Webster University
Interdisciplinary Science Building

Drawing Title: **SITE IMPROVEMENT PLAN**

C400

MSD P# 28874-01 MSD BASE MAP 23K2
MSD FIELD CHANGE 1 (SHEET 1 OF 4)

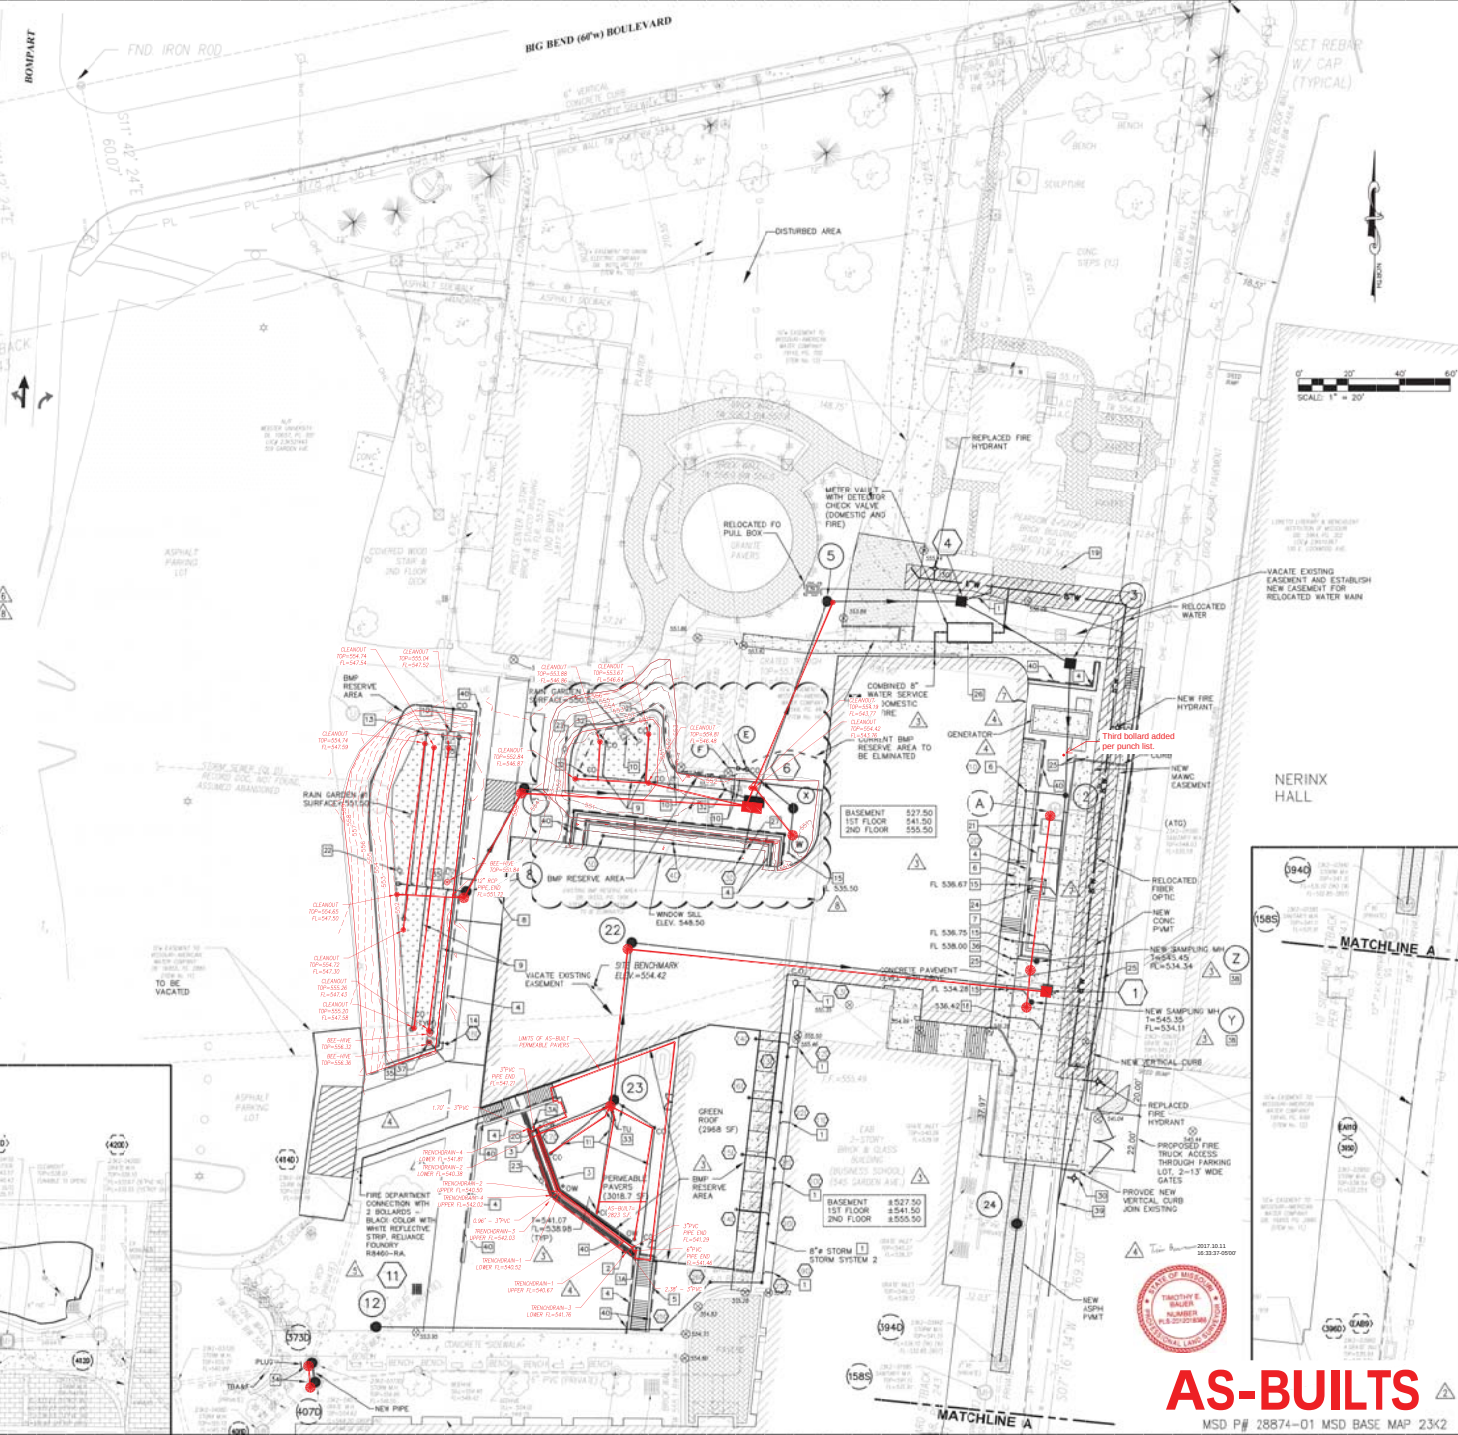
- INTERNAL CURB AND SIDEWALK.
- ADJUST LOCATION OF DRAINS AND PIPING BASED ON DOUBLE WALL CONFIGURATION.
- NEW HYDRO INTERNATIONAL 48" DOWNSTREAM DEFENDER.

- NEW FLOW SPLITTER MANHOLE.
- REMOVE AND REPLACE EXISTING BRICK SCREEN WALL, SEE ARCHITECTURAL AND STRUCTURAL.
- CLEANOUT (C3) TOP = 551.00, FL = 548.25 (TYP).

- TRAPPED UNDERDRAIN (20) TOP = 541.26, FL = 538.64 (TYP).
- FL = 538.98 (TYP).
- TORNA AT MID WARDSTORY DISCRETION.
- ROCK BLANKET (20'x10'x10').
- PRIVATE 8" PVC SANITARY SEWER LATERAL, 2" MIN FOR INTERIOR GREASE INTERCEPTOR.

- 8" FIVE BOLLARDS, TOP ELEVATION 552.50, CONNECT TO 4" BUILDING DOWNSLOPE PER DETAIL.
- NEW SAMPLING MANHOLE, CONSTRUCT OVER EXISTING SEWER.
- 4" RETAINING WALL, SUBGRADE, PERFORATED WHEN ADJACENT TO WALL AND SOLID AT ALL OTHER LOCATIONS, DAYLIGHT VIA BUBBLER.

- 4" RETAINING WALL, SUBGRADE, PERFORATED WHEN ADJACENT TO WALL AND SOLID AT ALL OTHER LOCATIONS, CONNECT TO BUILDING SUBGRADE SYSTEM.
